UNITED STATES PATENT AND TRADEMARK OFFICE

10/033,116

Raymond V. Damadian

DETAILED ACTION

FIG 1

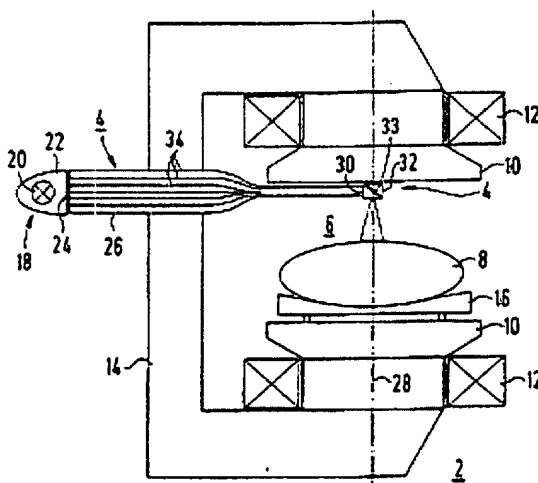
With respect to claims 42-46, Kuth shows in Figure 2 and discloses a

method of conducting a medical procedure (abstract), positioning a subject in an imaging volume (6) of a magnetic resonance imaging (MRI) magnet assembly (fig. 2, element 8); conducting a medical procedure on the subject (abstract); conducting magnetic resonance imaging of the subject (col. 1, lines 44-48); and flexing a light projector connected to the MRI magnet assembly to illuminate at least a selected portion of the subject (col. 1, lines 44-48), col. 3, lines 17-27), illuminating (30, 32, 33) the subject (8) with a light projector (32) connected to a canopy covering a pole of the magnetic resonance imaging system (see element 10 which is interpreted referring to pole shoes "covering" the poles thereby serving as "canopy"), wherein the MRI magnet assembly (12) is within a shielded room, illuminating the subject with a light projector optically coupled (30, 32, 33) to a light source (20) outside of the shielded room (see claim 1), further comprising conveying light from the light source to the light projector (see figure 1), through the canopy (10), conveying the light from the light source to the light projector by optical fibers (34) extending between the canopy and a pole (10 with insulated canopy cover) of the MRI magnet assembly (12), to the light projector (32).

Regarding claims 42-43, Kuth discloses a magnetic resonance system having illumination means that makes adequately high luminance for surgical procedures. (Col.1, lines 44-48).
